**GALWAY CITY COUNCIL
PEDESTRIAN CROSSING
LIOSBAN ROAD
STAGE 1/2 ROAD SAFETY AUDIT**

Document Control Sheet	
Document Reference	11266 TR02 RSA
Report Status	Final
Report Date	December 2023
Current Revision	A
Client:	Galway City Council
Client Address:	City Hall, College Road, Galway
Project Number	11266

Figure 2-1: Proposed Kerbing (Drawing 11266-6110-D02)

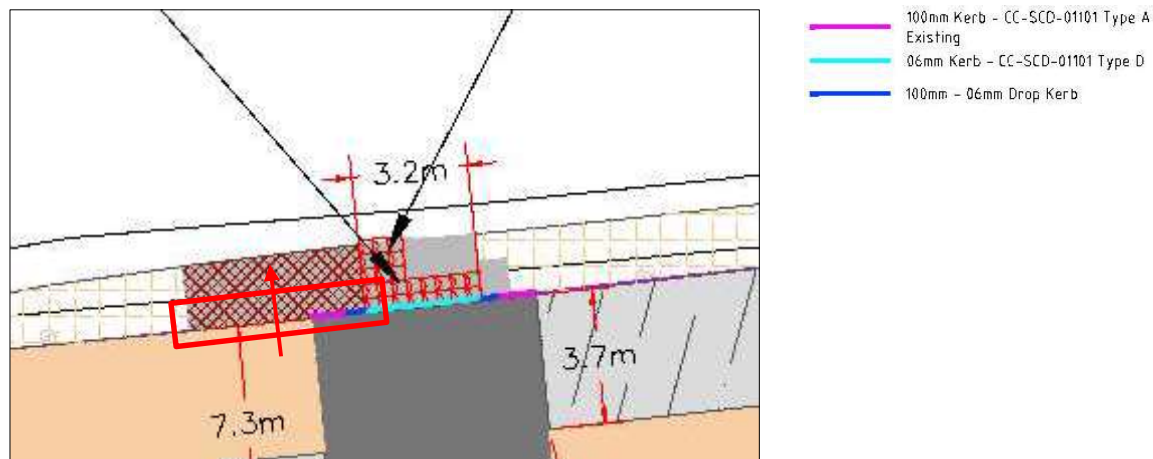
It was noted the proposed kerbing does provide access to the existing gate. The Audit Team are concerned drivers may increase speed on approach to mount the kerb. This may result in a collision between a vehicle and a VRU.

The design team should provide 25mm mountable kerbing across the existing access.

2.3	Yes	Yes			
2.4	Yes	No	Bollards with retention sockets to be placed along back of kerb to prevent vehicle parking along crossing and in front of gate and also the gate is used very infrequently so it is envisaged that the operators will remove bollards and open gate before attempting to enter through gates.

Figure 2-2: Proposed Gate Set- Back (Drawing 11266–6135)

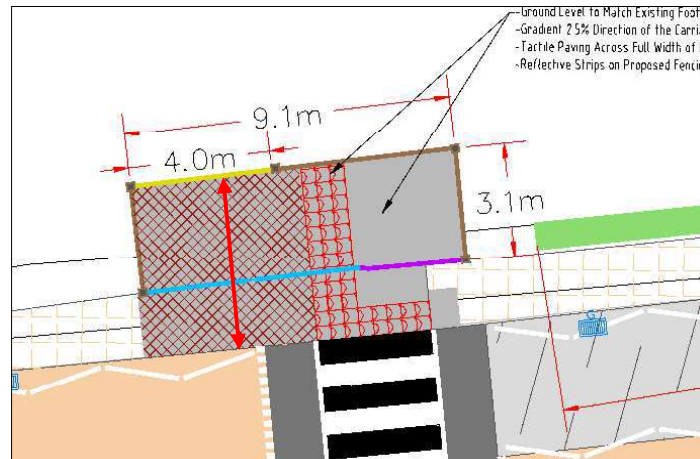
The Audit Team observed the proposed gate is approx. 5.1m from the road edge. The Audit Team are concerned a vehicle utilising the gate will not have sufficient room to set-down. The Audit Team are concerned a vehicle may partially set down on the road or proposed crossing this may lead in a rear end collision or obscure a VRU attempting to use the crossing .

The design team should ensure the gate is set back an adequate distance for a vehicle to safely set down away from the crossing point.

Figure 2-4: Vehicle Tracking (Drawing 11266-6140)

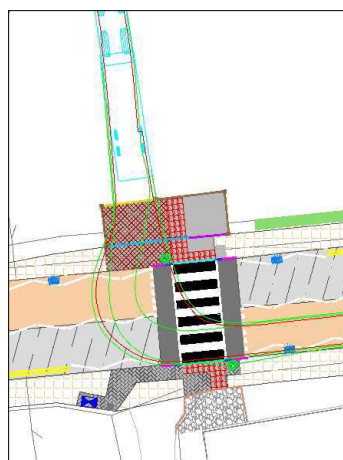
The Audit Team observed the vehicle tracking undertaken overruns into the footway. The Audit Team are concerned the proposed design has not allowed for safe access and egress from the gate. This may result in a collision between a vehicle and a VRU.

The design team to provide sufficient room for all turning manoeuvres.

2.5	Yes	Yes			
2.6	Yes	Yes

Drawing No. 11266-6100

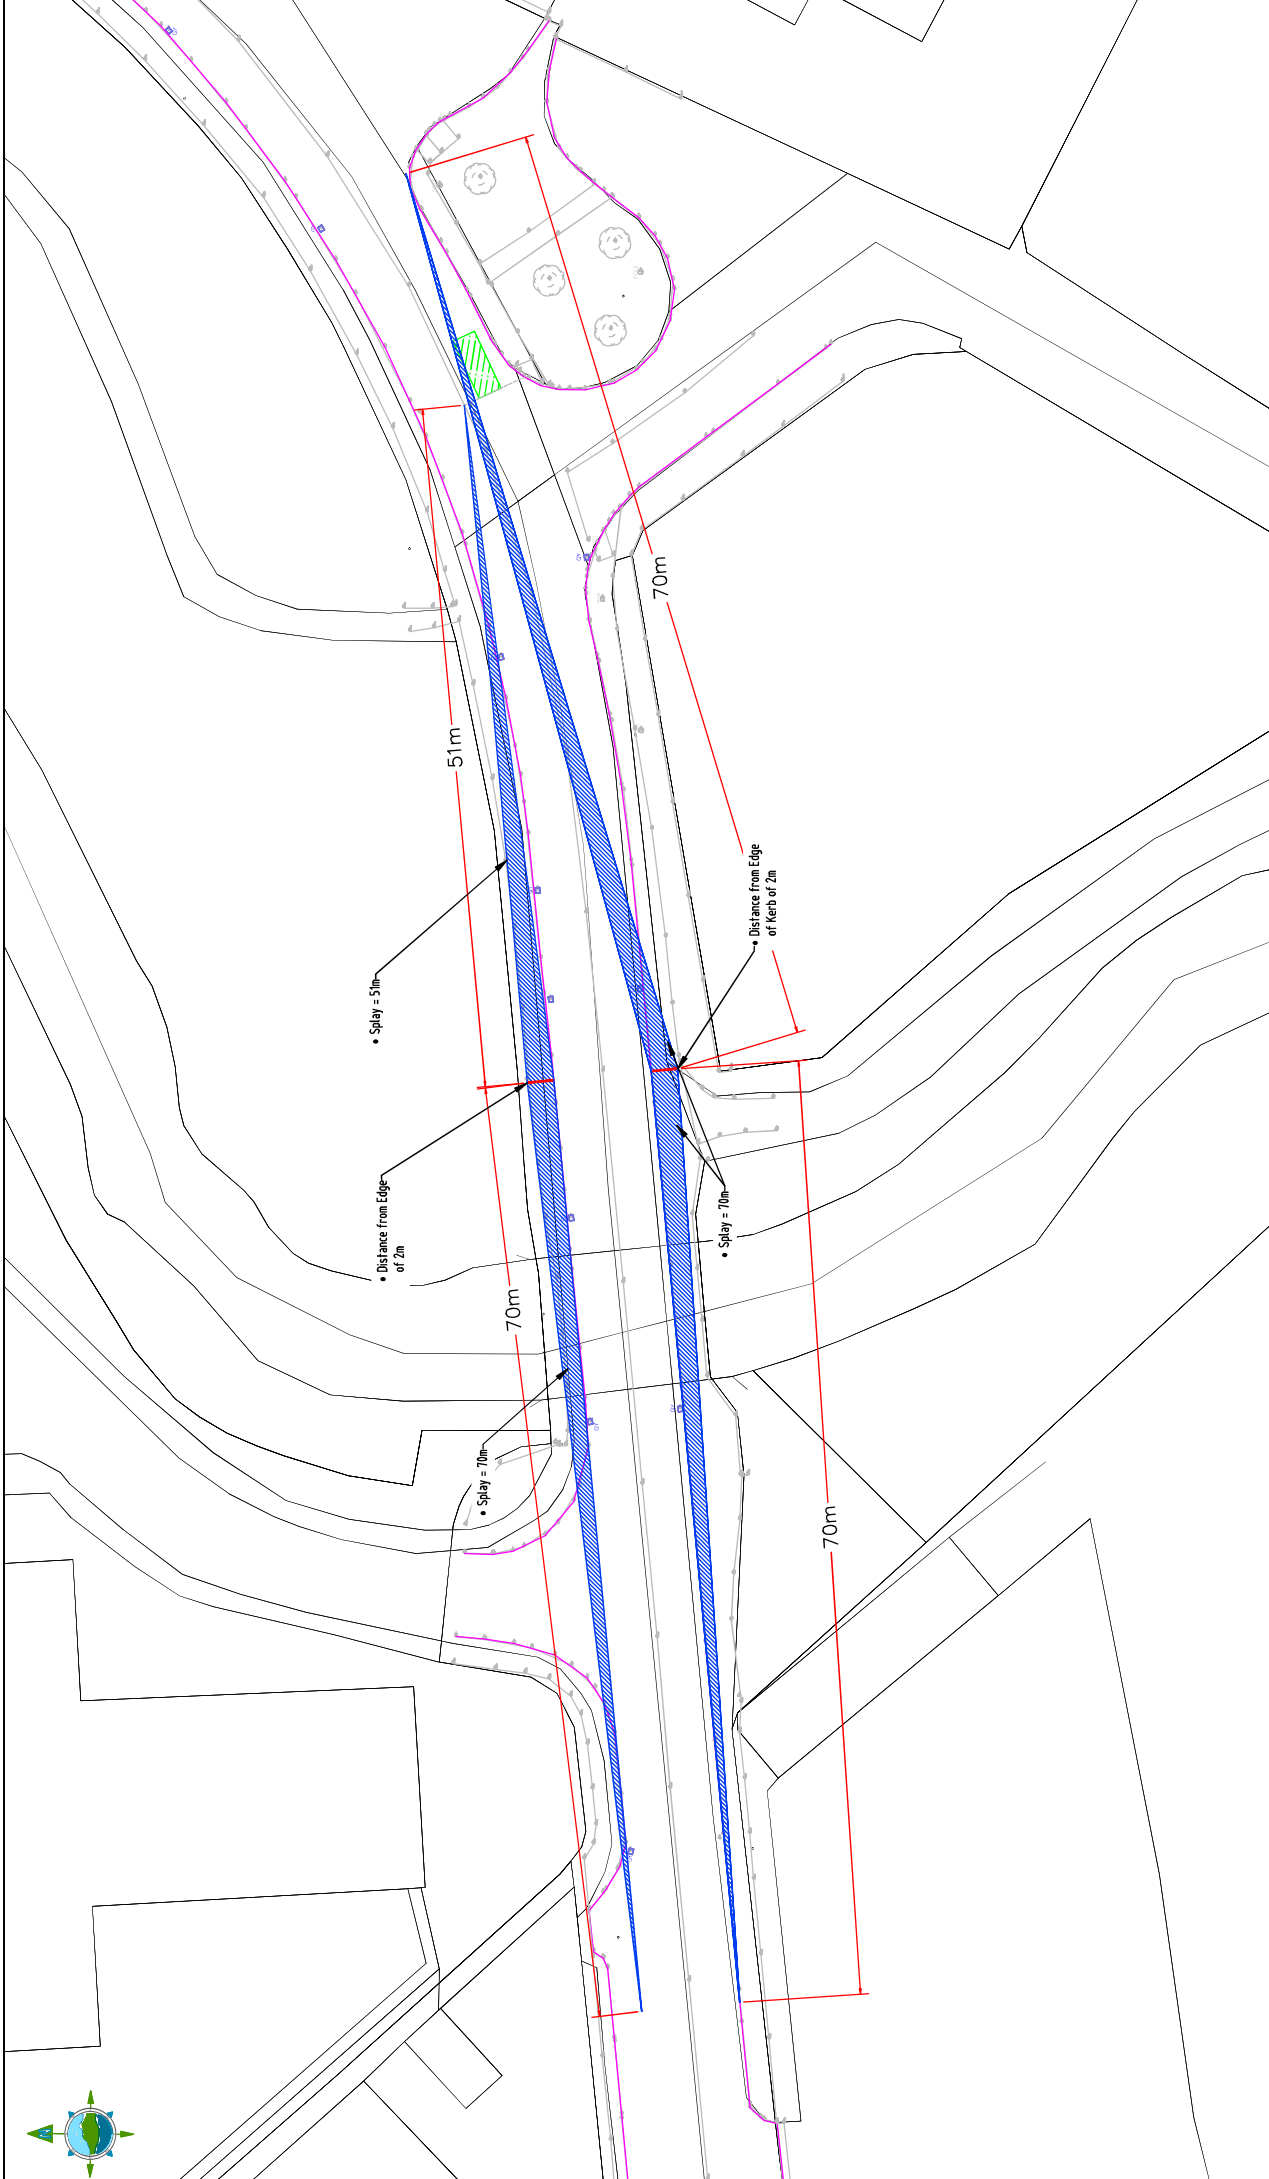
The Audit Team observed the proposed scheme does not incorporate a direct link from the crossing to the existing walkway. The Audit Team are concerned the proposed works will encourage pedestrian to enter the unpathed area through the upgraded gated and slip or trip on the uneven ground surface. The lack of a direct link may also discourage pedestrians approaching from the north side from using the crossing and lead to pedestrian crossing movements on the bend with reduced visibility where drivers are not anticipating any crossing movements to occur.

The design team should provide a link from the crossing to the existing forest walk.
